**MODIFICATION 01 - JUNE 2020**  
**SCHEDULE OF CHANGES**

32 The Strand Whale Beach				
SUMMARY OF BASIX COMMITMENTS				
This is a summary of the BASIX Commitments as detailed in the BASIX Certificate. Refer to the CURRENT BASIX Certificate for Complete details. For definitions refer to basix.nsw.gov.au				
WATER COMMITMENTS				
Fixtures				
3 Star Shower Heads		Yes ( > 4.5 but <= 6 L/min)		
5 Star Kitchen / Basin Taps		Yes	4 Star Toilet	Yes
Alternative Water				
Minimum Tank Size (L)		3000	Collected from Roof Area (m2)	70
Tank Connected To:				
All Toilets		Yes	Laundry W/M Cold Tap	Yes
One Outdoor Tap		Yes		
THERMAL COMFORT COMMITMENTS - Refer to TPA Specification on plans				
ENERGY COMMITMENTS				
Hot Water		Solar (Electric Boost) 21 to 25 STCs		
Cooling System	Living	1 Phase A/C Zoned		EER 2.5 - 3.0
	Bedrooms	1 Phase A/C Zoned		EER 2.5 - 3.0
Heating System	Living	1 Phase A/C Zoned		EER 2.5 - 3.0
	Bedrooms	1 Phase A/C Zoned		EER 2.5 - 3.0
Ventilation	1 x Bathroom	Fan ducted to exterior		Manual on/off

1 section  
200.01 1:100

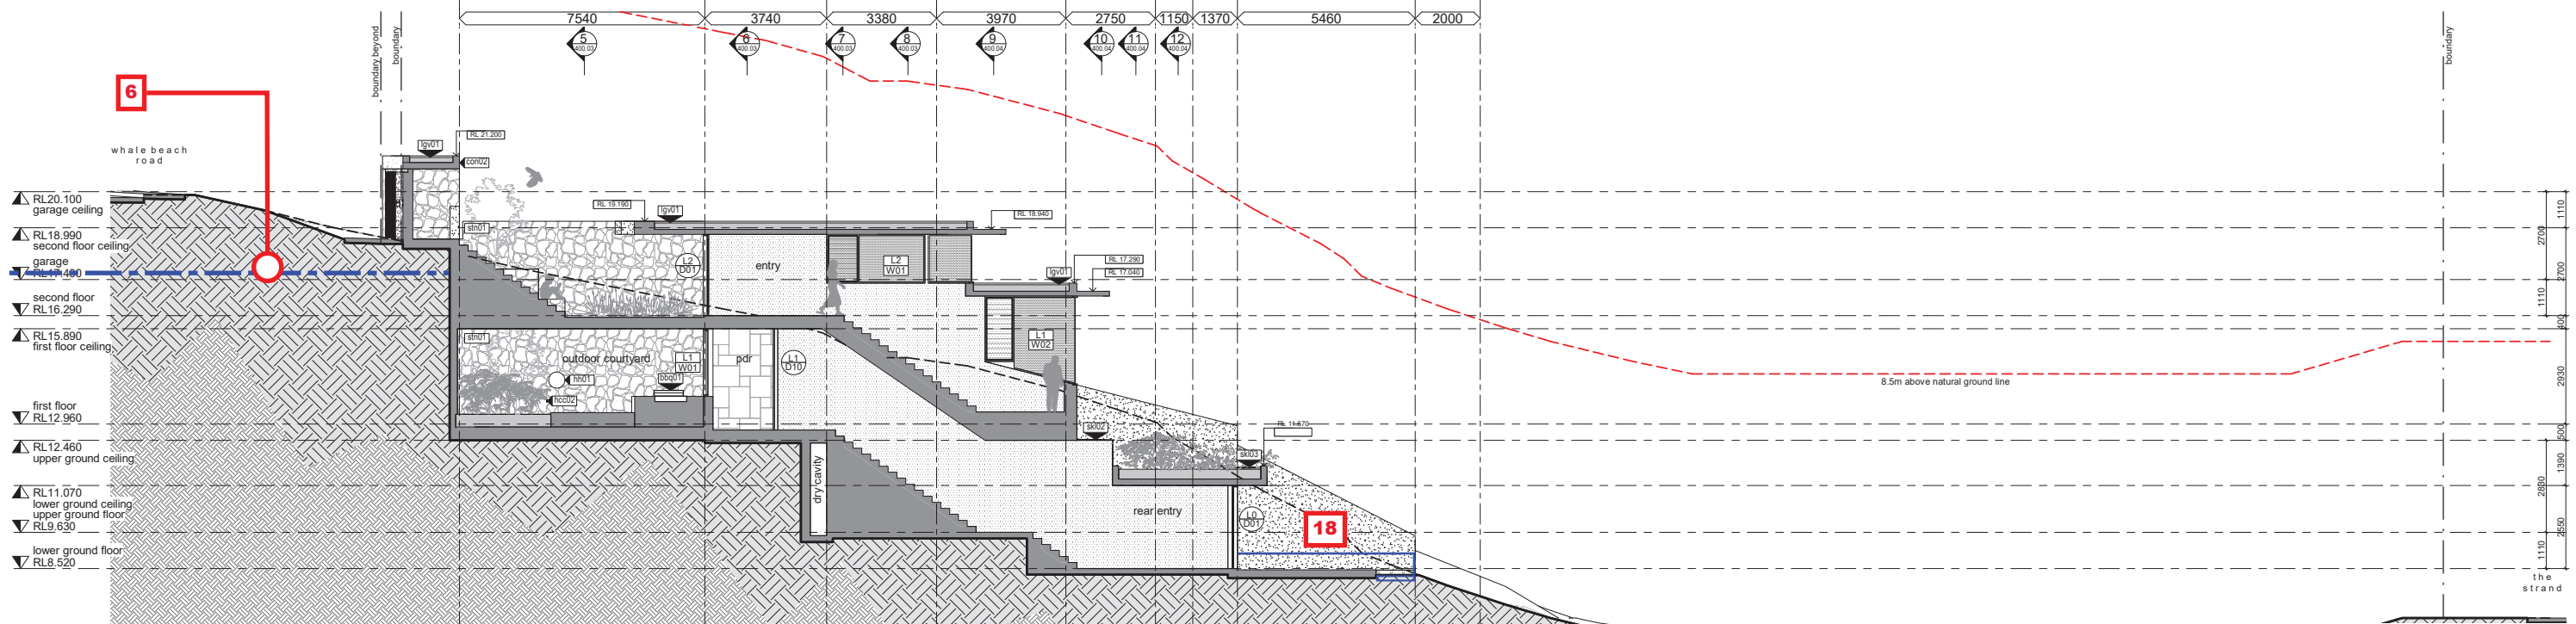
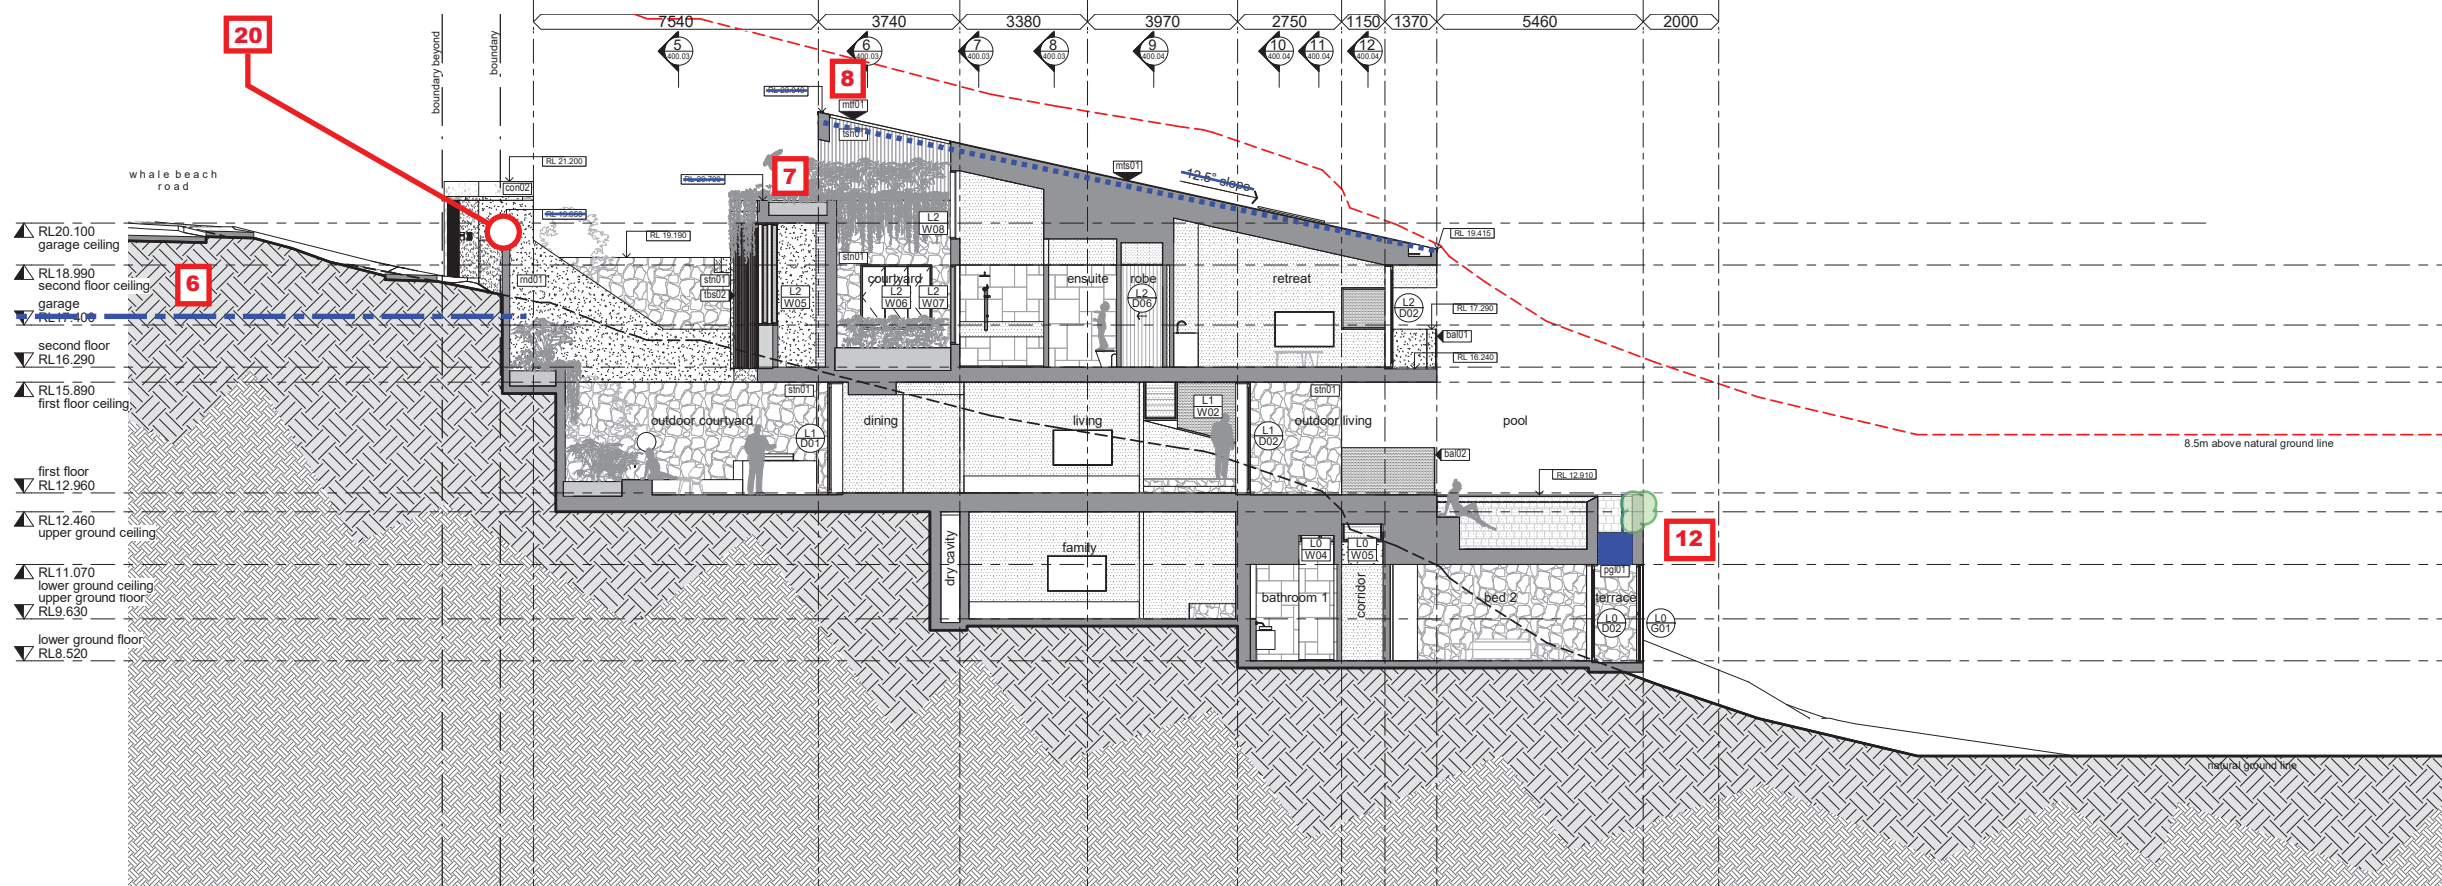
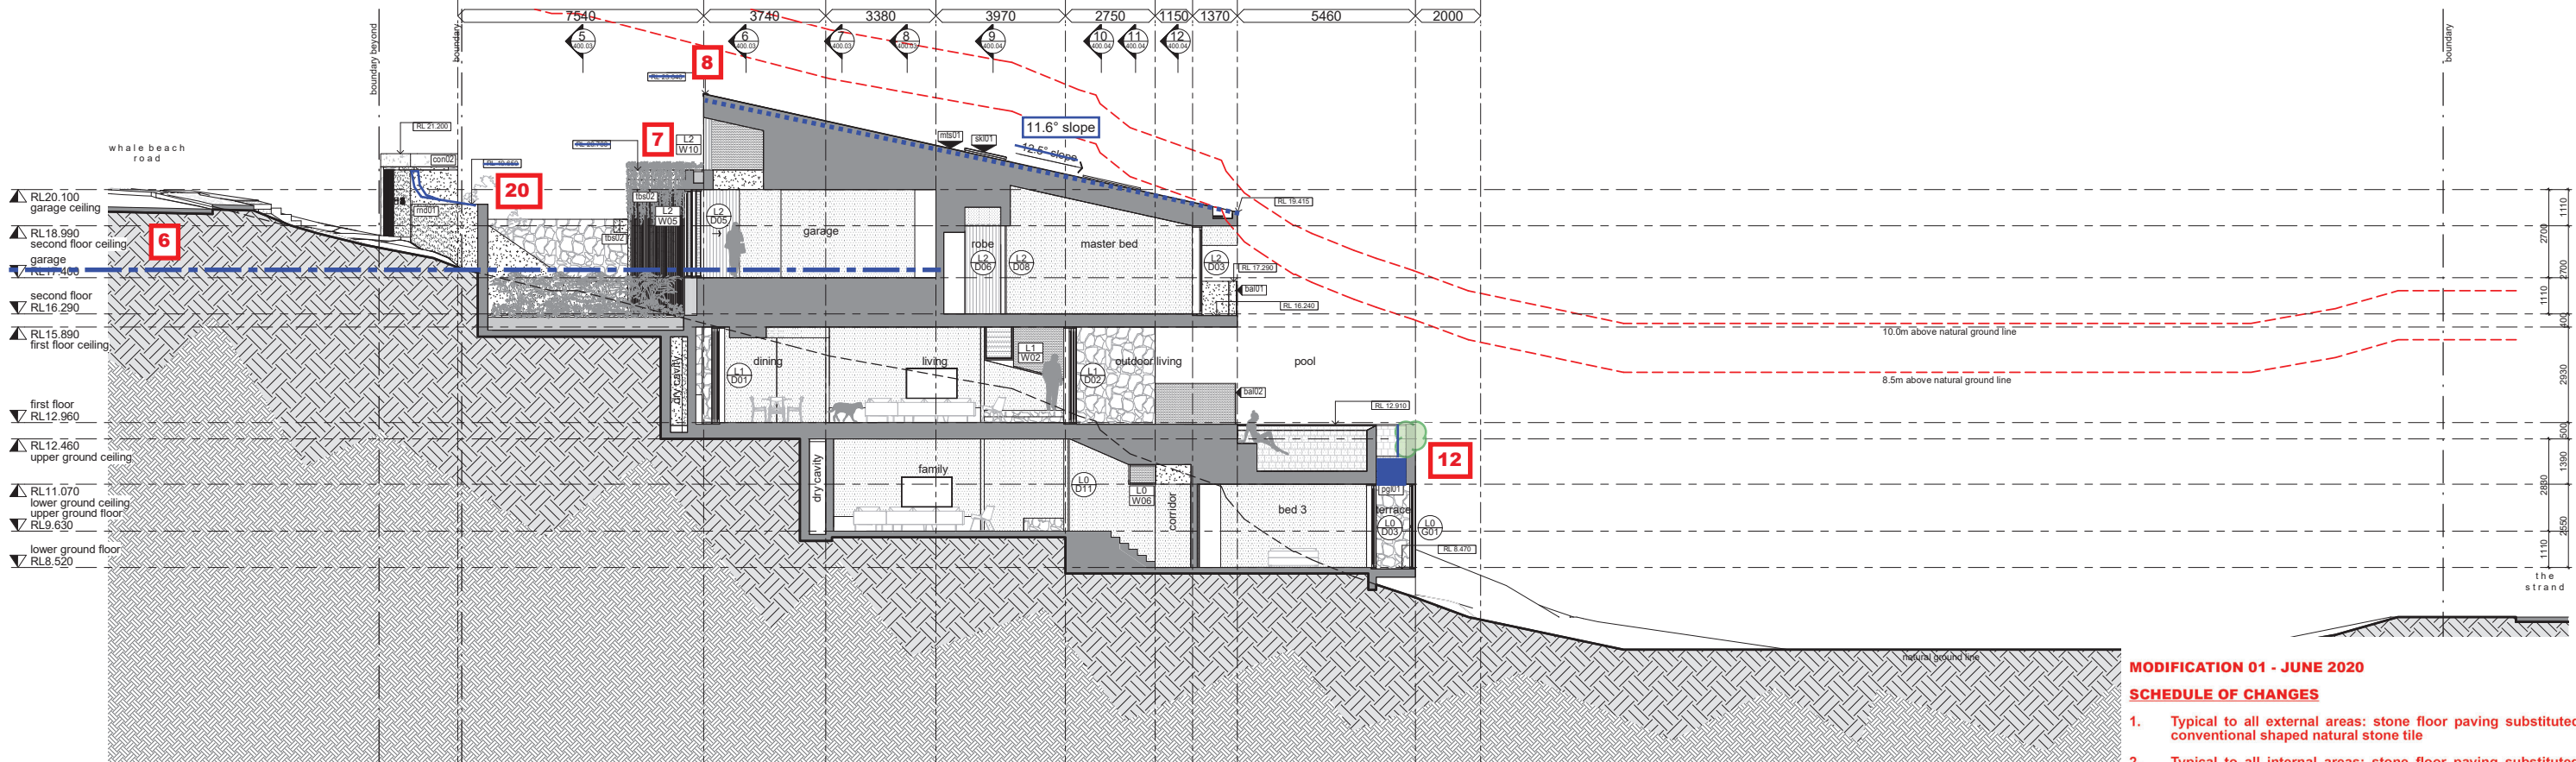
1. Typical to all external areas: stone floor paving substituted for conventional shaped natural stone tile
2. Typical to all internal areas: stone floor paving substituted for timber floors, and conventional shaped natural stone tiles in wet areas

3. Hard path and steps removed from architectural scope. Soft landscaping solution by landscape architect
4. Driveway finish changed and widened in accordance with consent SL2020/0241

5. Driveway levels modified to suit Council requirements in accordance with consent SL2020/0241. Car turntable added
6. Garage level raised by 300mm to RL17.700 as a result of accommodating [5]

7. Garage roof and garden edge lifted 150mm to RL20.850 as a result of accommodating [5] and [6].
8. Main roof ridge lowered by 290mm to RL22.750 as a courtesy to improve the view amenity of a neighbour to the west. Roof slope adjusted to 11.6 degrees.

9. Bin store reshaped and curved wall deleted. Bin store lid level shown at RL20.150. Refer to plans for dims where appropriate. Alteration in part as a result of compliance with prescribed conditions of consent (23) + (25) relating to tree protection and arborist's recommendations.

10. Minor alteration to configuration of glazing. Fixed glass to study. Glazed swing door out of laundry. Note net area and amount of glass remains unchanged.

11. Minor alteration to configuration of glazing. Refer to plan for relocation of walls. Note net area and amount of glass remains unchanged, floor area slightly reduced.

12. Swimming pool infinity edges (and associated ballast tank) deleted and zone changed to accessible path and landscaped wall/planter
13. Steps introduced to pool terrace to access service path. Refer to plans for dims where appropriate.

14. Extra solar panels added to increase energy efficiency of development
15. Block wall moved down to align with pool equipment adjacent as shown. Note this change is underground and not visible to the public or neighbours.

16. Plant and equipment store area increased by moving western wall further west in order to accommodate the required equipment with ventilation and service space. Refer to plans for dims where appropriate.

17. Block wall to be changed to screening for ventilation and sound attenuation
18. Seat added
19. Landscape plan amended in accordance with prescribed conditions of consent (15) + (38).

20. Height of landscaped wall facing street to be increased to the North to a max height of 1800mm above ground level to follow natural topography.
